**Commonwealth Edison**

January 8, 1988

Subject: Byron Station Units 1 and 2  
Braidwood Station Units 1 and 2  
Application for Amendment to Facility  
Operating Licenses NPF-37, 66, 72 and 75,  
Appendix A, Technical Specifications  
NRC Docket Nos. 50-454/455 and 50-456/457

# Commonwealth Edison B/B Nuclear Power Stations

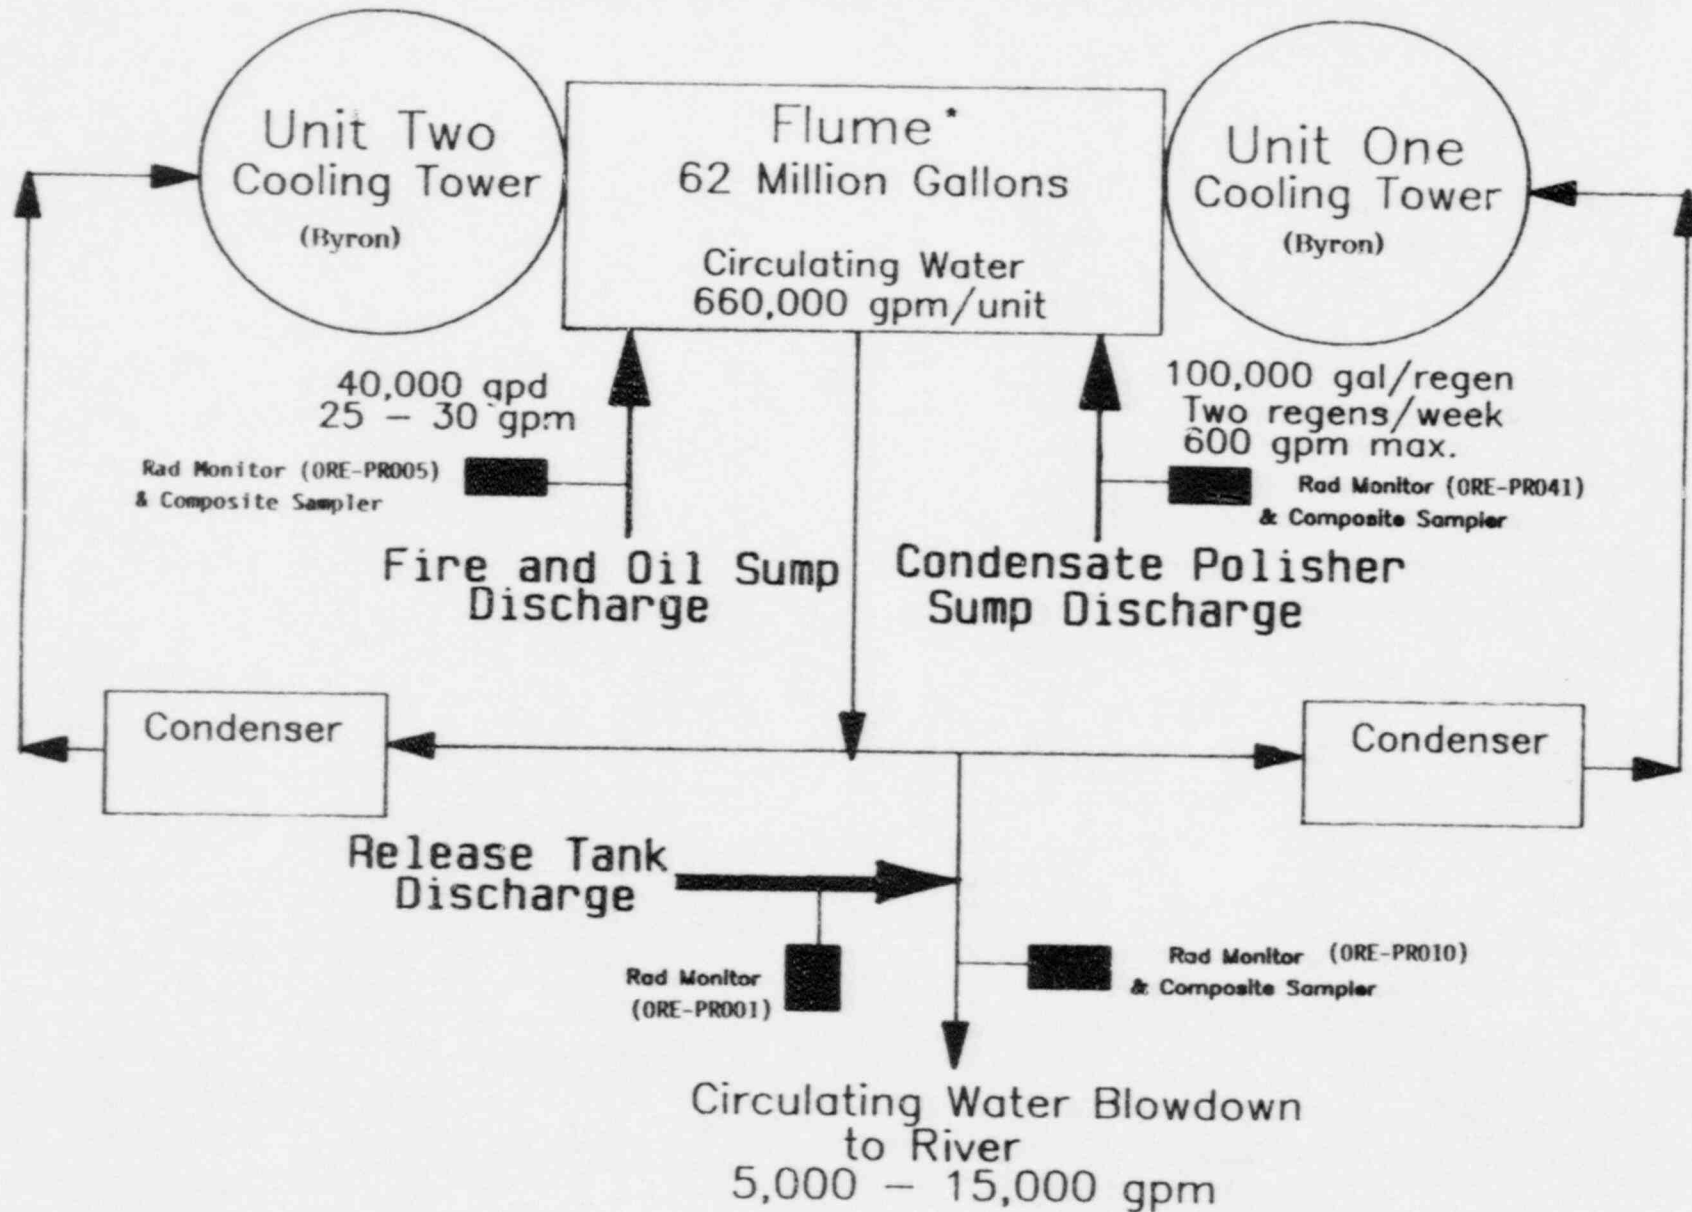
Both the fire and oil sump and the condensate polisher sump will discharge into the 62 million gallon volume of the flume. At Braidwood, the body of water is the lake, which has a volume of approximately 8 billion gallons. The circulating water pumps (not shown) take suction from the flume and discharge to the condenser which flows to the cooling tower which has a water basin adjoining the flume. At the discharge of the circulating water pumps, prior to the condenser, the station blowdown line diverts a portion of the water for discharge offsite to the river. There is a radiation monitor and composite sampler on the station blowdown line. If the radioactivity limits exceed the radiation monitor setpoint, discharge of radioactive effluent through the station blowdown lines will be terminated. The liquid release tank discharges into the station blowdown line upstream of the blowdown line radiation monitor. There is also a separate radiation monitor on the liquid release tank discharge.

The proposed technical specification amendment incorporates two radiation monitors and composite samplers to monitor discharge from the turbine building fire and oil sump and the condensate polisher (CP) sump. The condensate polisher sump discharges directly into the flume (lake for Braidwood). A radiation monitor and composite sampler are located on the discharge of the CP sump. The fire and oil sump discharges to the flume (lake for Braidwood) via the treated waste system. The radiation monitor is located on the fire and oil sump discharge to the treated waste system. The composite sampler is located on the treated waste system discharge to the flume (lake for Braidwood). The fire and oil sump discharges approximately 40,000 gallons per day at a rate of 25 to 30 gallons per minute. The condensate polisher sump discharges approximately 100,000 gallons of water per condensate polisher bed regeneration. The Station estimates that typically two regenerations will be performed per week. The maximum discharge rate is 600 gallons per minute. If radioactivity levels exceeded their setpoints, the discharge into the flume (lake) from the fire and oil sump or the condensate polisher sump would be terminated.

# Commonwealth Edison B/B Nuclear Power Stations Secondary System

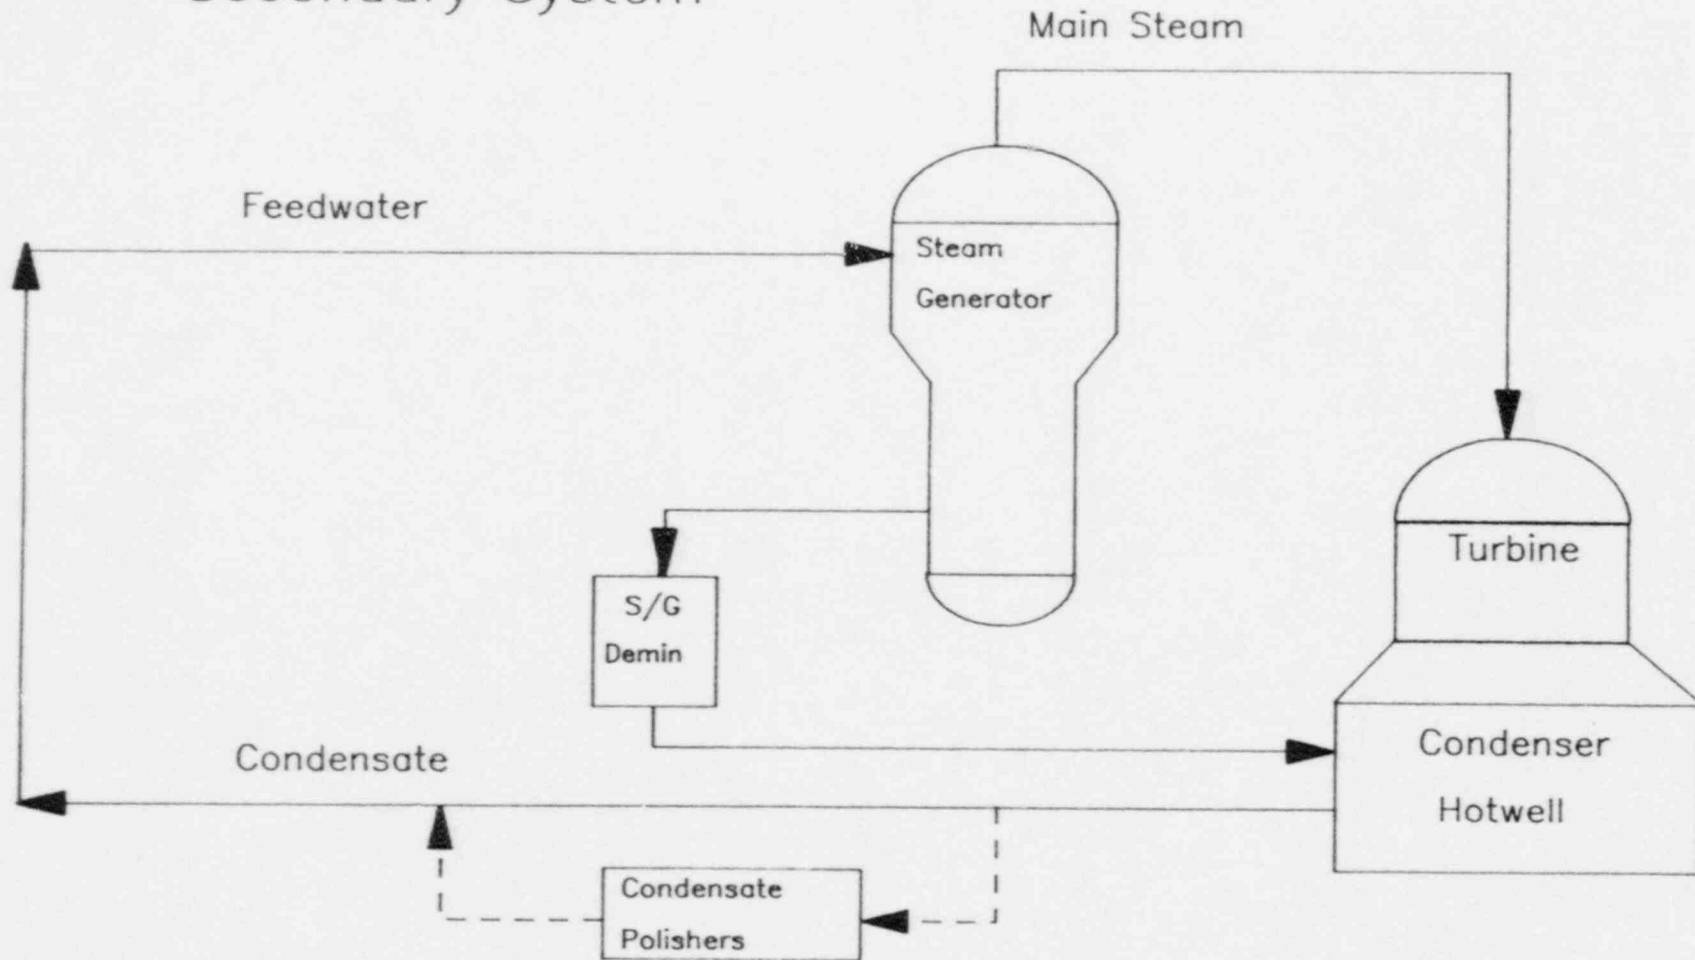
As noted on the drawing, the condensate polishers can process between 20 and 30% of the secondary side flow at full power. The condensate polishers are operated as necessary to maintain steam generator chemistry requirements. Steam generator blowdown is processed separately. It is sent through a steam generator demineralizer back to the condenser hotwell.
